Subject: CLUNKING NOISE FROM NO. 3 ENGINE MOUNT	Bulletin No: 01-011/14
	Last Issued: 04/15/2014

2007-2012 CX-7

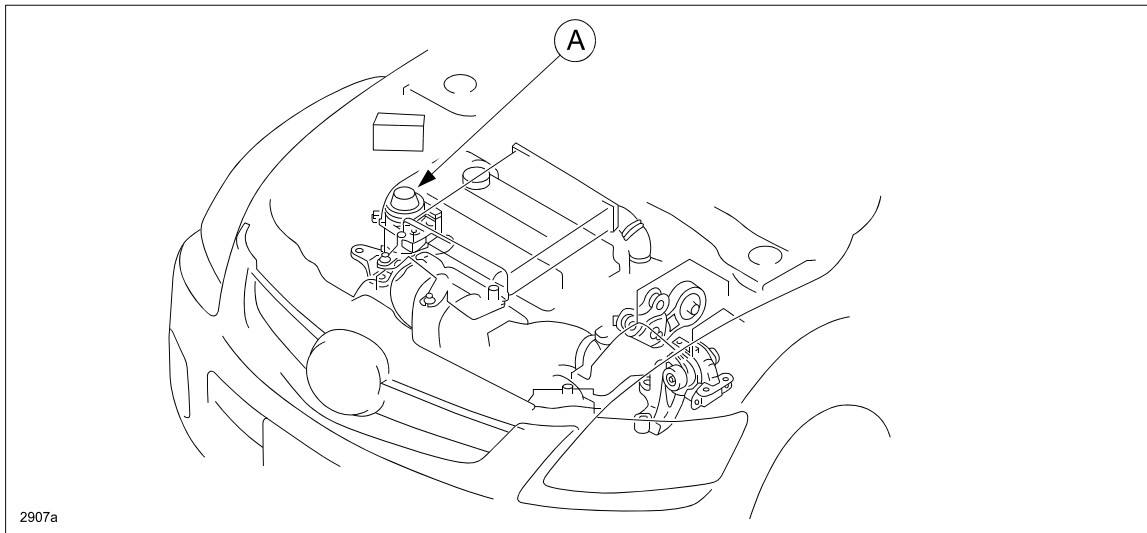
Some vehicles may exhibit a clunk noise from the engine compartment when driving over rough roads or over a speed bump. The noise may occur in areas of high ambient temperatures.

Due to high heat, the lubricant inside the No. 3 engine mount rubber (A) may become ineffective, causing a stick-slip noise between the casing and the rubber, however, there is no seepage from the engine mount.

The engine mount rubber uses a new type of lubricant to eliminate this concern.
